**TO:** DEVELOPMENT REVIEW BOARD **DATE:** August 21, 2003  
**FROM:** CURRENT PLANNING SERVICES  
**SUBJECT:** CASE 44-DR-2003  
**REQUEST:** Approve site plan, landscape plan, and elevations for an automobile dealership facility  
**PROJECT NAME:** Lund Cadillac  
**LOCATION:** SEC Loop 101 & Scottsdale Road

**REQUEST:** The applicant seeks approval of site plan, landscape plan, and elevations for a new automobile dealership facility. The facility includes three (3) individual dealership buildings, a small test track, and a future pad site for a body shop.

CADILLAC BUILDING ELEVATIONS

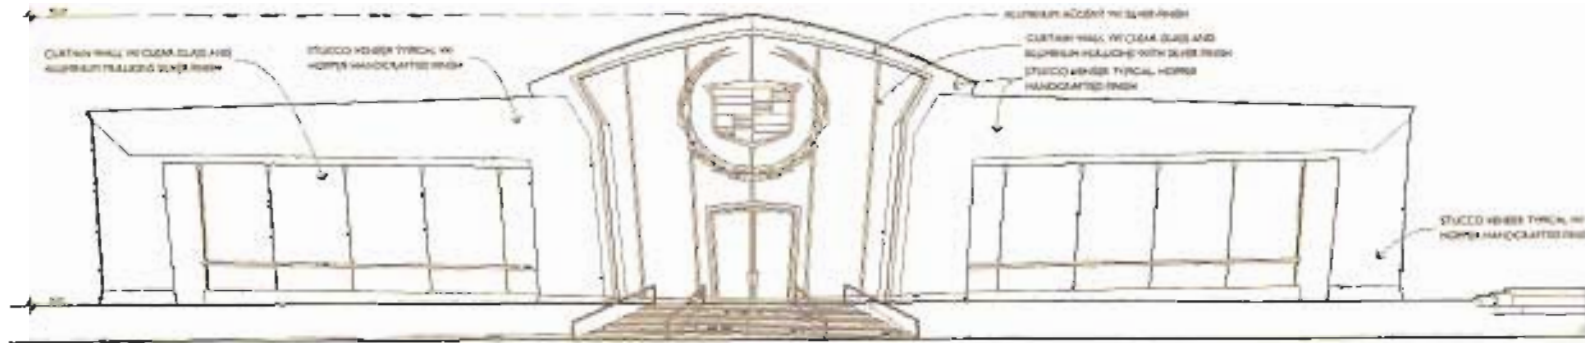
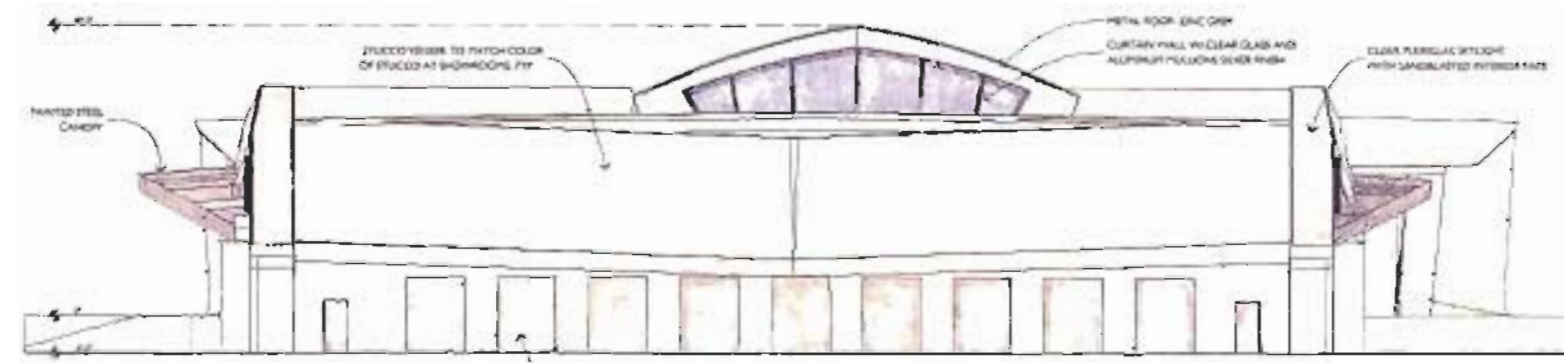
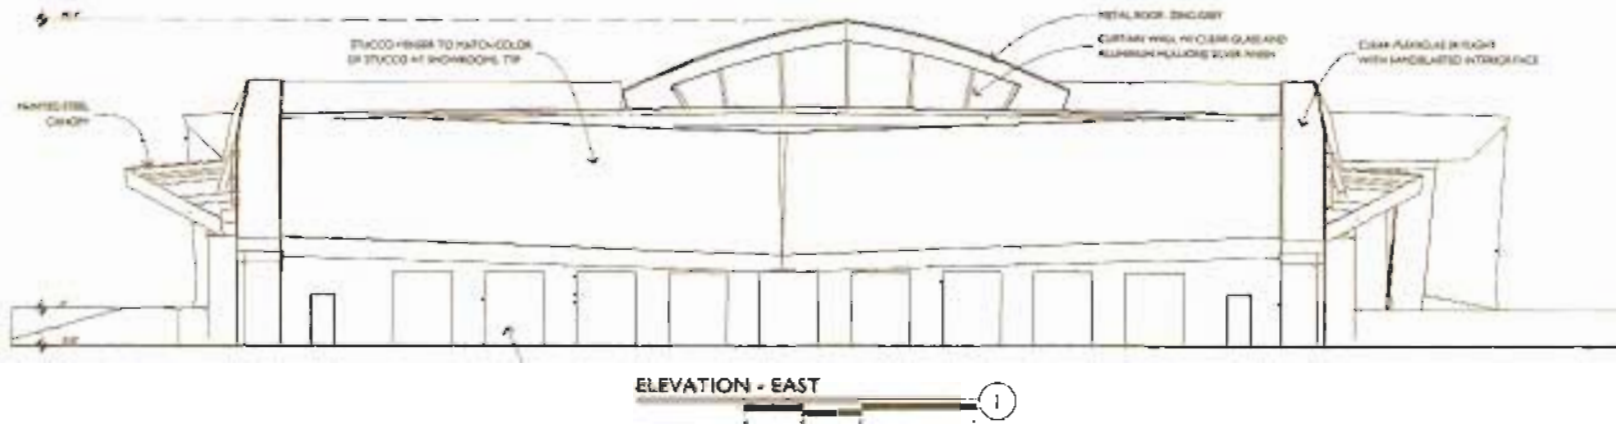
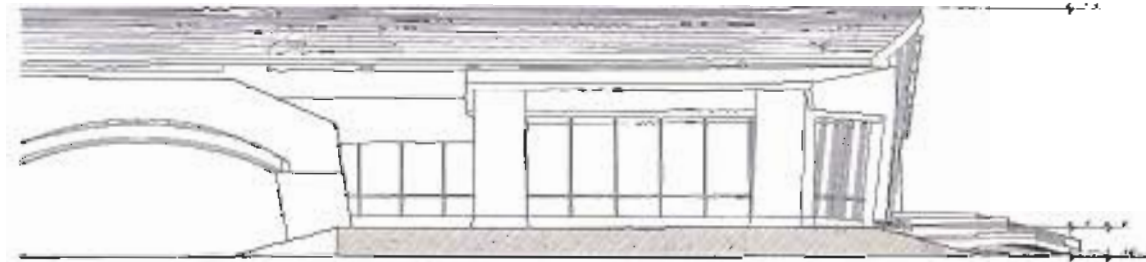
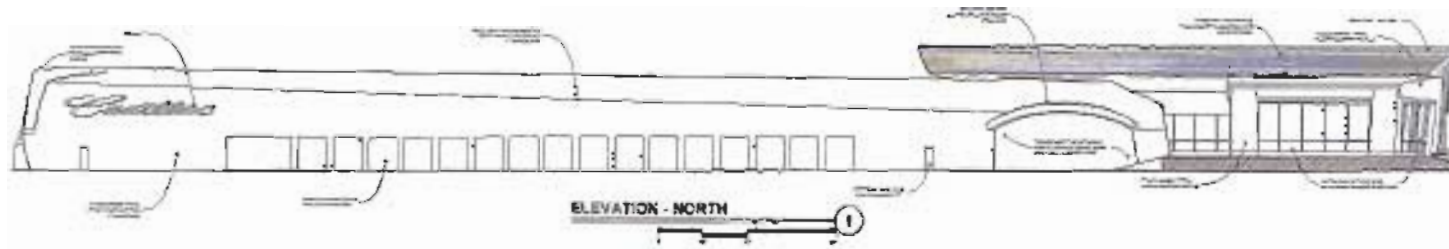
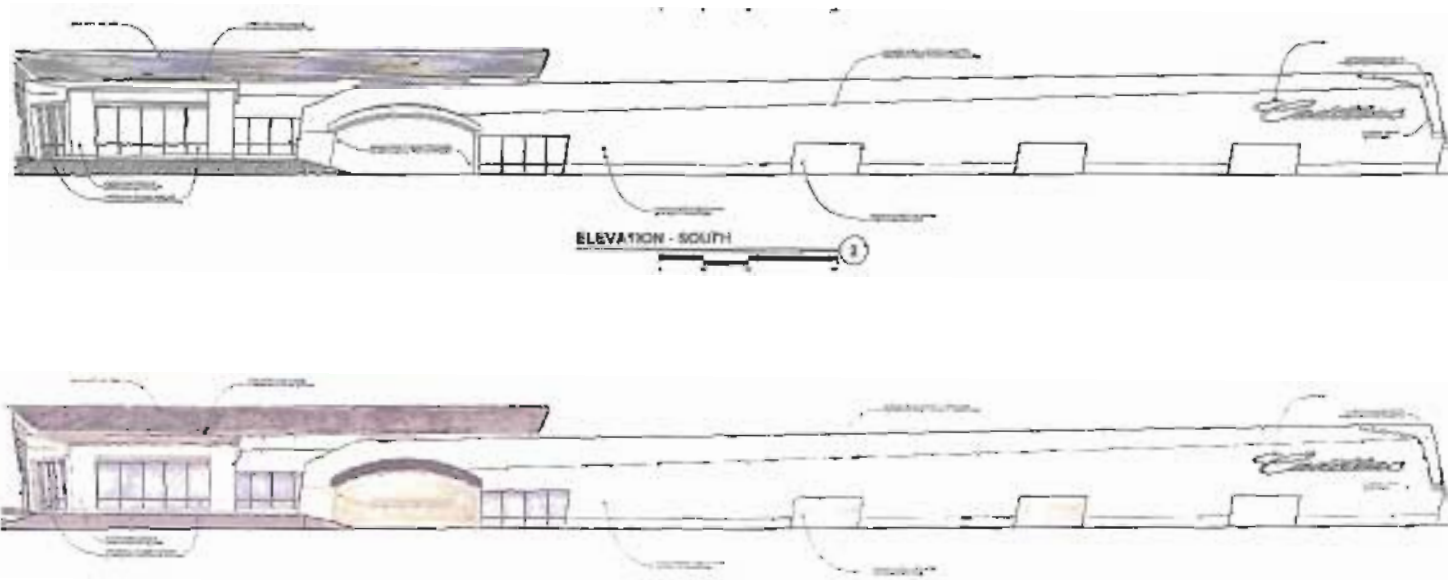
The center dealership building consists of light tan stucco veneer with a hopper handcrafted finish, curtain wall clear glass windows, and a clear glass window tower element that includes the dealership symbol. This building, the largest building on the site, is designed to resemble an automobile with many unique features. The building extends approximately 500 ft. to the east, parallel to the Loop 101, portraying the rear fenders of a Cadillac automobile. A clear plexiglass skylight with a sandblasted interior face has been placed at the upper corners of the north and south facades of the building to indicate taillights at the rear of the building. Staff has been consistently working with the applicant regarding this idea and has created a stipulation to ensure light levels, architectural integrity and design can be modified as the project develops with a site inspection prior to Certificate of Occupancy to ensure the appropriateness of such a design feature.

The eastern ends of the north and south elevations (rear of the building) depict long continuous horizontal massing with minimal breaks in the parapet. The applicant has angled the roofline from the showroom mass to the tail light feature. This long elevation is also broken up with angled vehicle doors on the south side, an overhang reveal in the stucco and the tail light feature.

HUMMER BUILDING ELEVATIONS

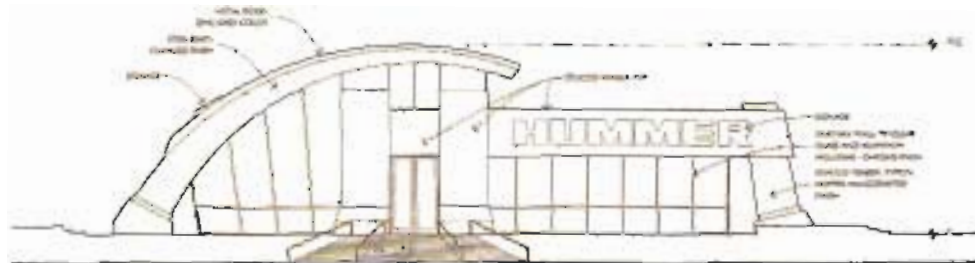
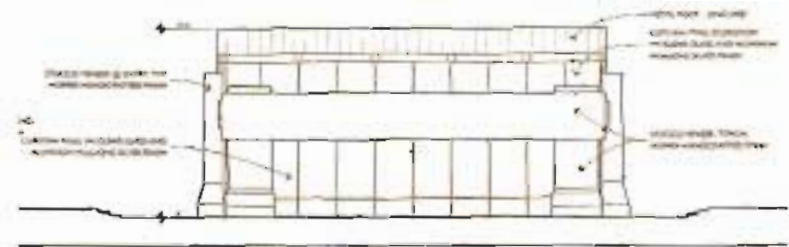
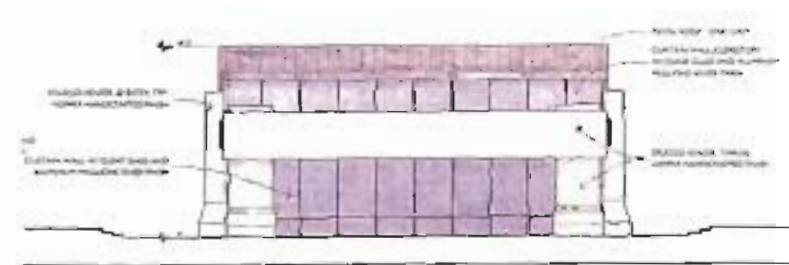
The Hummer dealership building is located north of the Cadillac building. The building consists of a semi-circular grey standing seam roof over the showroom, facing the Loop 101, with a wing addition. The design is taken from the military Quonset hut and its relationship to the vehicle product of the business. The entire western and eastern façades contain a curtain wall of clear glass except for the main entrance, which is

Staff expressed concern with the "H" design. The applicant has revised this design element to raise the central beam to match the lower parapet height across the remainder of the building and utilize the same materials as the remainder of the building vs. distinguishing the element with other materials.

SAAB BUILDING ELEVATIONS

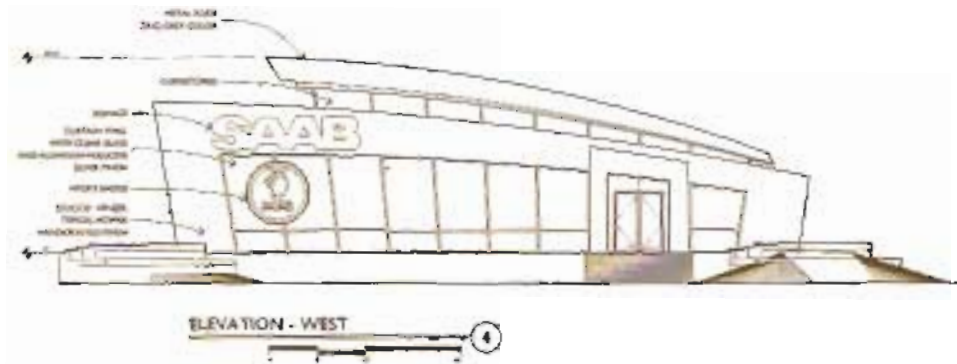
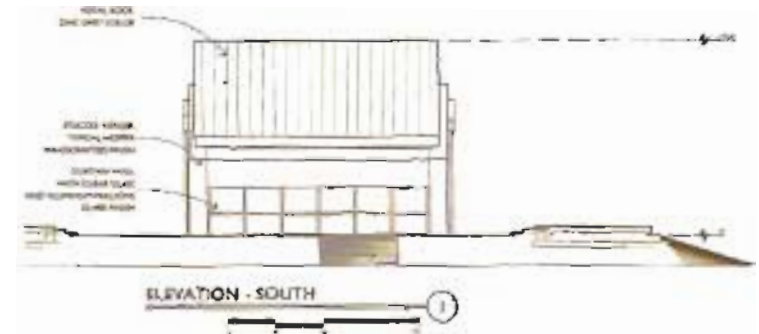
The Saab dealership building is located south of the Cadillac building. This building also consists of a semi-circular grey standing seam roof over the showroom. Both the eastern and western facades contain a curtain wall of clear glass that is broken up with a horizontal wall element. As with the two other buildings, the walls are composed of light tan stucco veneer with a hopper handcrafted finish to the building.
